Access Compliance Report

Public Rights-of-Way

(Curb Ramps)

Intersection ID: 27786	Main Street: BISHAR_LN	Cross Street: BRICK_CHURCH_CT	Location: W
ADA ID: 903D0778D23F	Ramp Type: PerpDiag	Initial Pass/Fail: Fail	Overall Compliance: No
Severity Score: 17.5			
Codes/Mitigation Info/Possible Solution		Field Measurements/Component Compliance

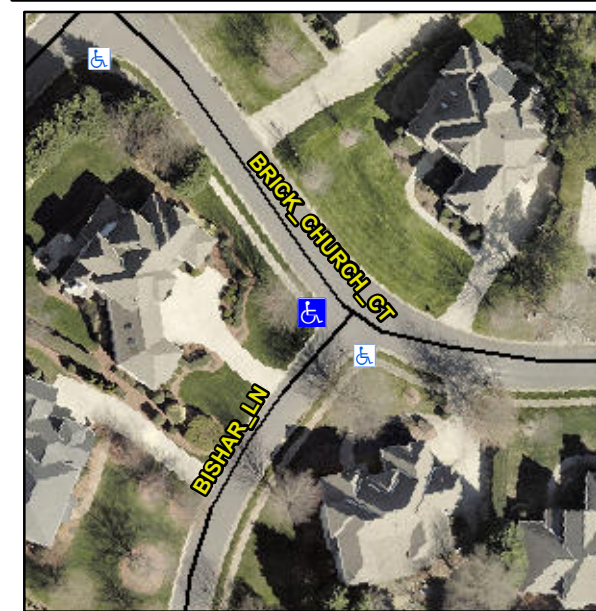
Not Found, R304.5.1

Compliance	Description	Data	Compliance	Description	Data
N/A	Ramp Length (in)	96.0	Yes	Ramp Slope (%)	5.4
No	Ramp Width (in)	34.0	Yes	Ramp XSlope (%)	0.1
N/A	Flare Type LT	N/A	N/A	Flare Type RT	N/A
N/A	Flare Slope LT (%)	N/A	N/A	Flare Slope RT (%)	N/A
N/A	Flare Traversable LT?	N/A	N/A	Flare Traversable RT?	N/A
N/A	Landing Length (in)	N/A	N/A	DWS Provided?	N/A
N/A	Landing Width (in)	N/A	N/A	DWS Contrast?	N/A
N/A	Landing Slope (%)	N/A	N/A	DWS Length (in)	N/A
N/A	Landing X Slope (%)	N/A	N/A	DWS Full Width?	N/A
N/A	Landing Curb? (Y/N)	N/A	N/A	DWS Offset (in)	N/A
N/A	Shared Landing?	N/A			
N/A	Gutter Ponding?	N/A	N/A	Gutter Slope (%)	N/A
N/A	Gutter Lip Ht (in)	N/A	N/A	Gutter X Slope (%)	N/A
N/A	Painted X Walk1?	No	N/A	Painted X Walk2?	No
	X Walk 1 Direction	To SE		X Walk 2 Direction	To NE
N/A	X Walk 1 Width (in)	N/A	N/A	X Walk 2 Width (in)	N/A
	X Walk 1 Slope (%)	2.9		X Walk 2 Slope (%)	1.0
	X Walk 1 X Slope (%)	1.0		X Walk 2 X Slope (%)	3.3

Remove & Replace Curb Ramp With Two New Directional Ramps or Equivalent.
